Gateway Determination Report

LGA	Ryde
PPA	City of Ryde
NAME	Proposal to increase the permitted height and floor space ratio at 112 Talavera Road, Macquarie Park (1250 dwellings, 100 jobs)
NUMBER	PP 2018 RYDEC 001 00
LEP TO BE AMENDED	Ryde Local Environmental Plan 2014
ADDRESS	112 Talavera Road, Macquarie Park
DESCRIPTION	Lot 422 DP1221081
RECEIVED	10 January 2018
FILE NO.	IRF18/460
POLITICAL DONATIONS	There are no donations or gifts to disclose and a political donation disclosure is not required
LOBBYIST CODE OF CONDUCT	There have been no meetings or communications with registered lobbyists with respect to this proposal

Figure 4: Extract from Ryde LEP height of buildings map depicting existing height controls.

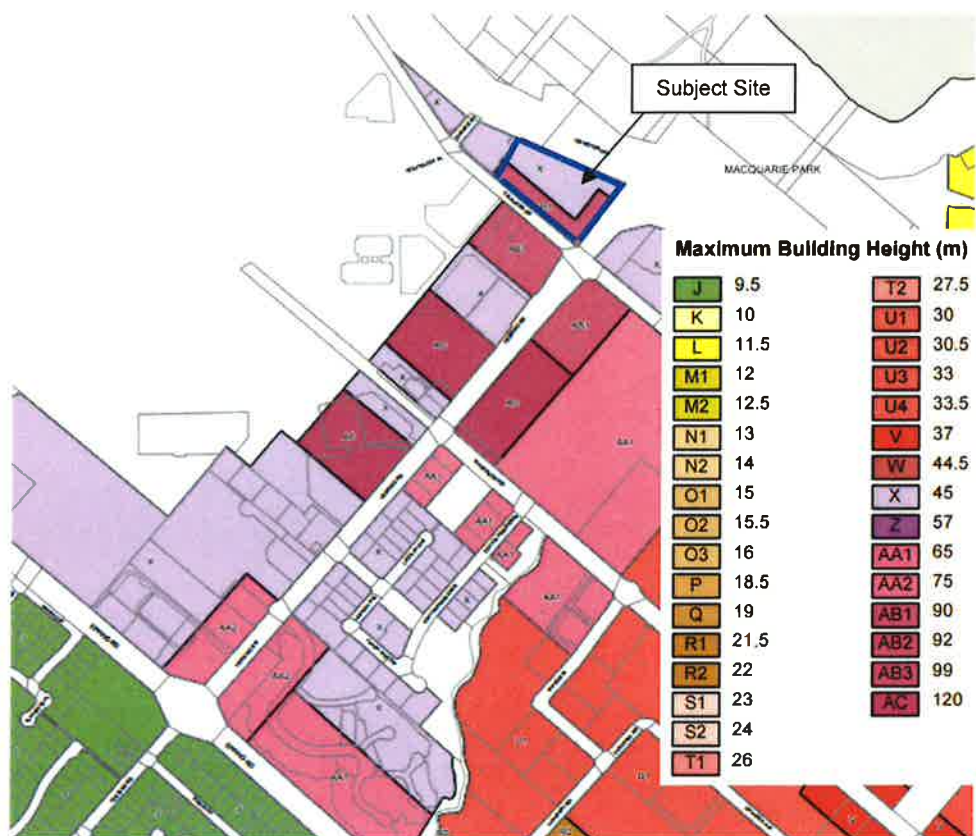
As shown in Figure 4 (page 5), the existing controls under Ryde LEP provide two different height limits across the site – 45m to most of the site and 90m along the site's southern and eastern boundaries. As such, the proposed height increase will not undermine the intended gateway effect of the Herring Road finalisation report as the highest point of any future development may be concentrated towards Herring Road.

Figure 7: Extract from planning proposal depicting proposed height of buildings map.

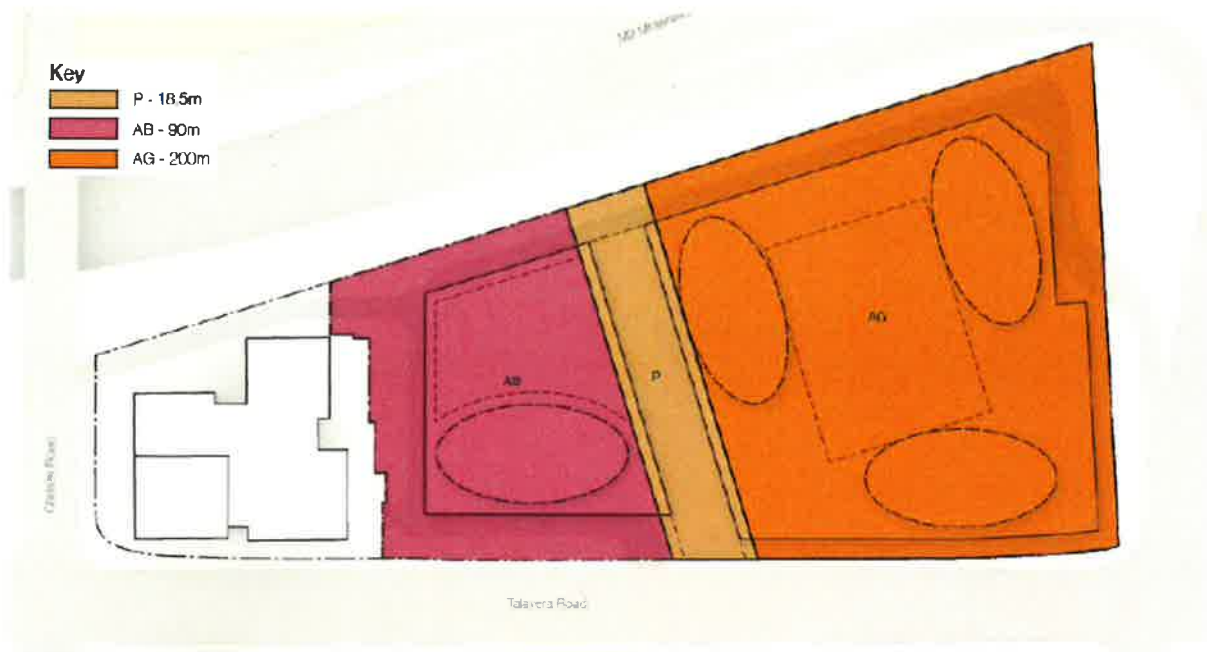
The proposed increase will also provide a similar transition to the Fujitsu building to the west as the existing height controls, with a change in height at the boundary from 45m to 90m (Figure 7, page 7). The intended podium of 18.5m in the concept scheme would soften the transition between the two sites and provide a human scale to the proposed development site.

Figure 9: Proposed building heights and airspace surface heights.

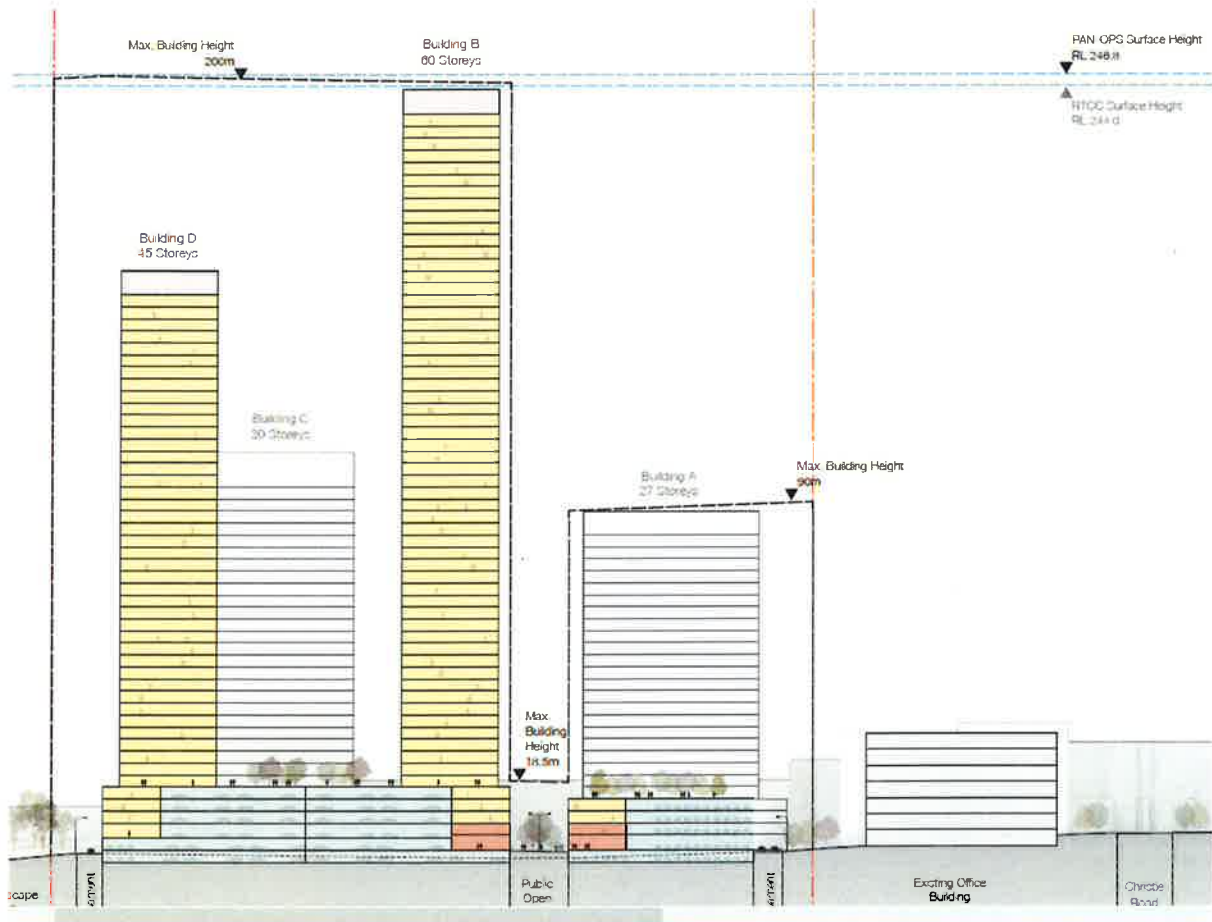
Figure 9 demonstrates that the proposed building height is immediately below the PANS-OPS and RTCC heights, but does not show the TAR clearance plane.

The height assessment considers a proposed maximum building height of 200m AHD and concludes that the proposal will not infringe on the prescribed airspace of Sydney and Bankstown airports. However, temporary penetration of the above surface heights and clearance plane by construction crane(s) will require further analysis and consultation. It is noted that the proposed maximum building height is measured from existing ground level, which is approximately 47m AHD, thereby making the potential height of development 247m AHD. This outcome would result in an exceedance of the airspace controls for the site.

The planning proposal must be updated to include an assessment of the airspace controls that apply to the site and to note that consultation is required to satisfy consistency with this Direction. To avoid confusion, the planning proposal must also be updated to clarify how the maximum building height of 200m is measured.

Figure 10: Extract of shadow analysis of indicative scheme from urban design report.

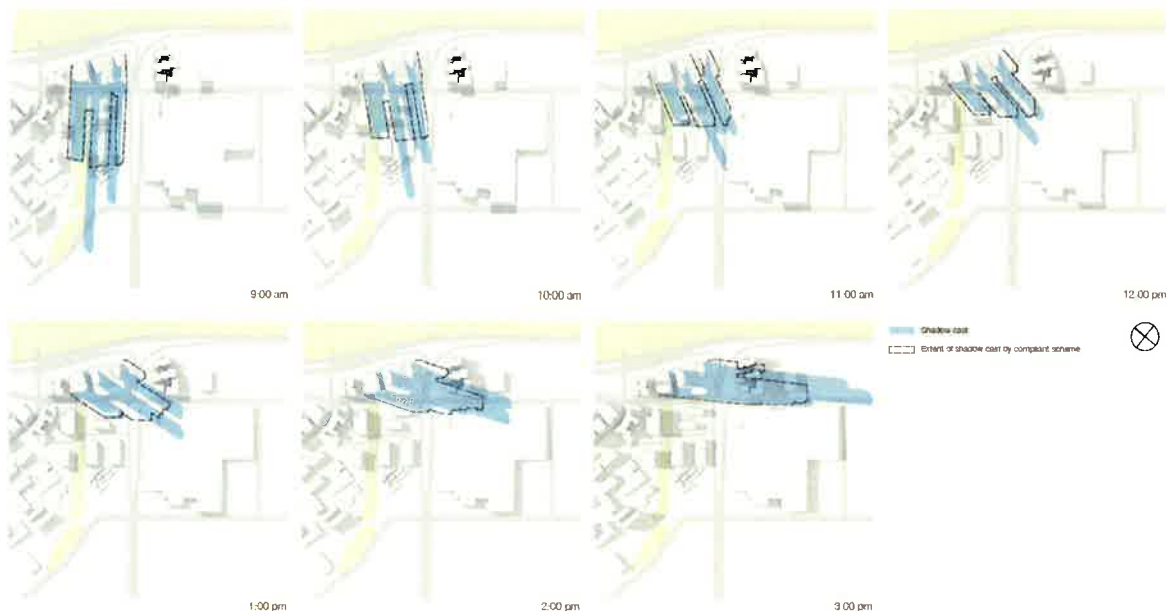
The proposal is supported by shadow diagrams depicting the impact of the concept scheme on neighbouring properties from 9am to 3pm during the winter solstice (Figure 10, page 15).

The drawings compare the proposed scheme with a compliant scheme under the existing controls, stating that the additional height will allow for more slender towers and provide better solar access. While the compliant scheme is not relevant as any proposed development would be required to address solar access impacts, the drawings demonstrate that a development under the proposed controls can generally provide adequate solar access to neighbouring properties.
